SUBJECT: Trowbridge Dam, Dam ID No. 604; Allegan County

**DAM SAFETY INSPECTION REPORT  
TROWBRIDGE DAM – DAM ID NO. 604  
KALAMAZOO RIVER  
ALLEGAN COUNTY – SECTION 12, T 01N, R 13W**

**INSPECTION DATE:** August 18, 2023

**Photo #1 – Aerial imagery of dam after Phase 1A repairs. More significant deficiencies and their locations are identified**

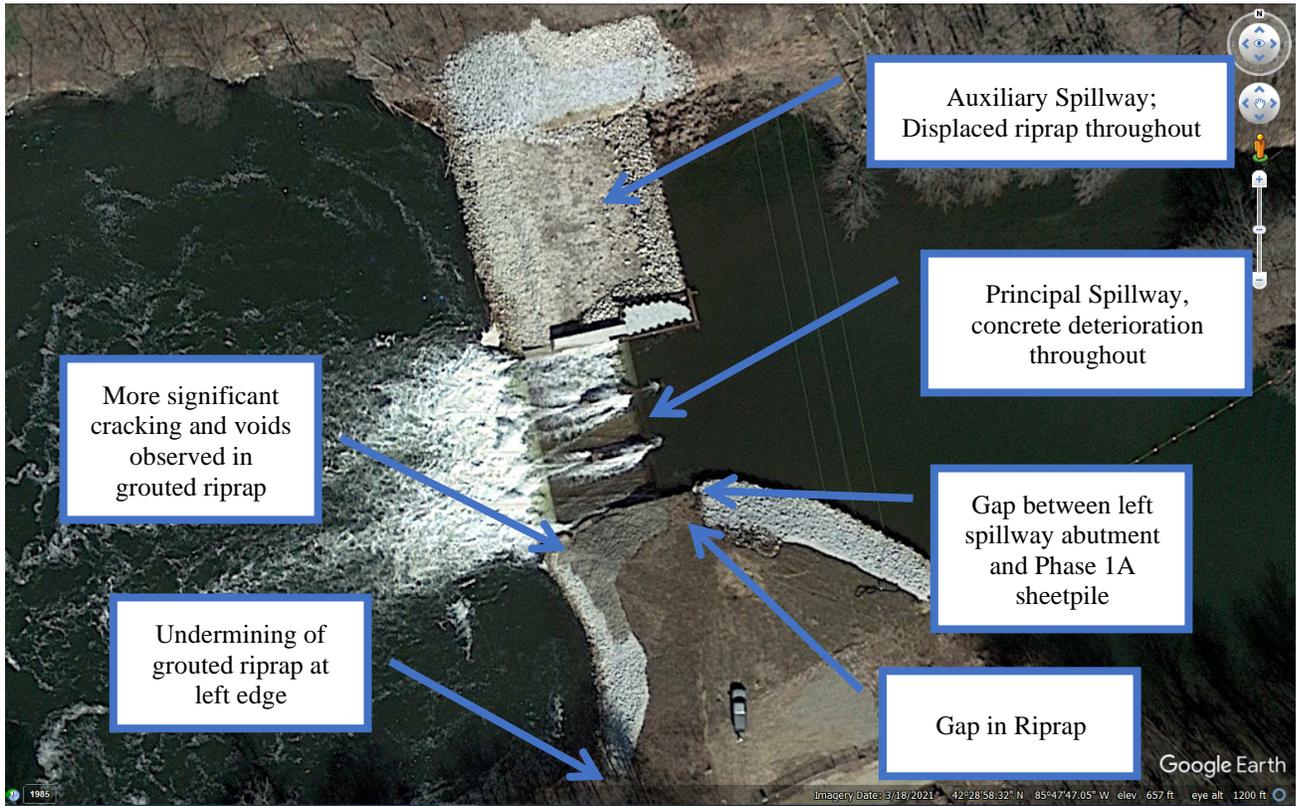
1. Continue to prepare the design for dam removal of the Trowbridge Dam. Work completed as a part of Phase 1A of the removal project has greatly increased the safety of the dam, but it was intended to provide temporary stabilization until the dam can be fully removed. The anticipated service life of the Phase 1A repairs was 3 years, from completion in 2019. Since the Phase 1A repairs did not incorporate standard design practices for a dam of this size, specifically the design utilized sub-standard stilling basin and energy dissipation practices, the threat of scour and undermining of the structures increases over time. Since the intended service life has been surpassed, additional monitoring, maintenance, and interim repair of the structure may become necessary to ensure stability until the dam can be removed. Enlist the services of a qualified engineer to assess the stability of the structure for the remaining lifespan of the dam. This stability analysis should be completed by July 1, 2024, and any recommended repairs should be implemented as directed by that engineer.

2. Trowbridge dam has a significant lack of hydraulic capacity to pass the design flood of the 200-year event. During the design storm, the principal spillway left abutment is expected to be overtopped by approximately six feet, while the pier between the principal and auxiliary spillways is expected to be overtopped by approximately five feet per the 2019 hydraulic model submitted as part of the Phase 1A permit application. The Phase 1A project provided armoring of the earthen abutments to an elevation above the 200-year design flood event, however there is a gap in the armoring at the left embankment between the old grouted riprap on the downstream portion of the embankment and the new riprap on the upstream portion of the embankment behind the new sheetpiling wall. This gap could allow erosion of the earthen abutment or eventual flanking failure of the spillway during a large flood event. Additional armoring material should be

added this location to match the elevation of the Phase 1A grouted riprap. There is also a gap between the principal spillway left abutment and Phase 1A sheetpile wall where the gap in grouted riprap exists. Sandbags are stacked in the gap, but flow through or over the sandbags could still cause erosion of the embankment behind the abutment wall and sheet piling. This should also be sealed and armored to protect against erosion. These repairs should be completed by July 1, 2024.

3. Significant voids and cracks in the old grouted riprap on the left embankment downstream slope were observed throughout, especially near the principal spillway outlet. Some brush was growing within larger voids. Flow over the grouted riprap raises concerns of instability during large floods. Also, the left end of the downstream riprap has undermining occurring from tailwater conditions during some flow events. Continued undermining could cause instability of the embankment slope. Monitor grouted riprap areas on a monthly basis for further deterioration. Fill/repair any deteriorated areas as they are observed.

4. Monitor the concrete components of the principal spillway for further deterioration and movement, especially along the left spillway abutment wall, including the downstream training wall that is significant misaligned. Remove all brush and vegetation growing within cracks in the concrete walls and piers of the principal spillway by December 31, 2024.
